COM refinement for Annex 120D CDAUI (C2C) suggested in D1.1 comments 29-31, 82, and 122

Richard Mellitz, Intel Corporation

TP0a
after
filter

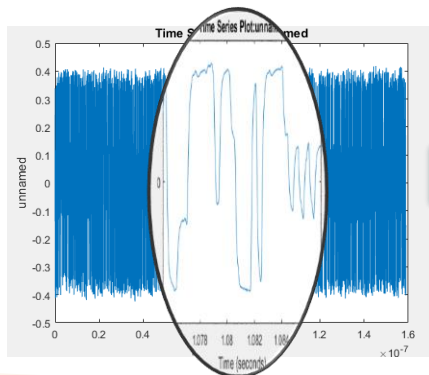
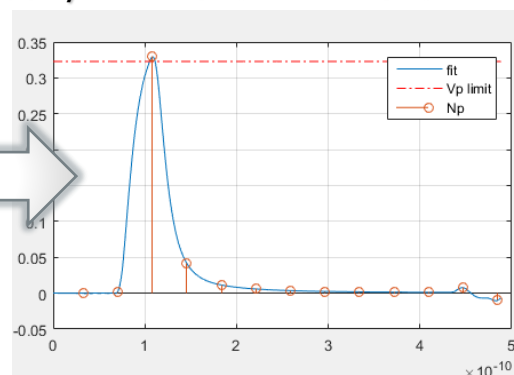
- Change
 - $Z_c=85$
 - $A_v=A_{fe}=0.445$
 - $A_{ne}=0.645$
 - $n_p = 13 (d_p+n_b+1)$
 - $SNR_{Tx} = 33.67$ for COM
- SNR_{TR} with 6.3 mV of σ_{e} removed = 33.67dB
- $V_f =$
 - 30mm pkg: $.403V \geq .4V$
 - 12mm pkg: $.600V \leq .6V$
- $V_{peak}/V_f = 0.81 \geq 0.8$

If SNDR is
set to 29 dB
 SNR_{TX}
should be
31.1dB

COM incremental change results (dB)

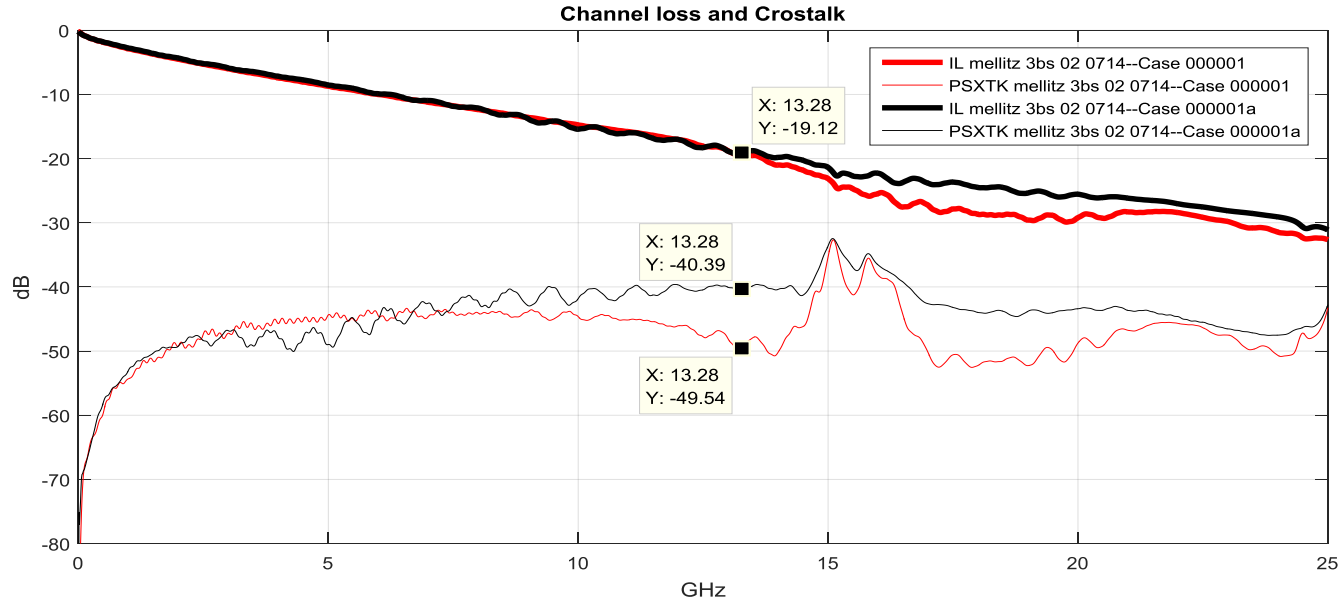
Channel index 9 is channel index 1 with improved reflections

- However channel index 9 (case 00001a) resulted in more crosstalk than channel index 1(case 00001)
- Conclusion: 20 dB channels are not very tolerant of crosstalk

COM table Recommendation
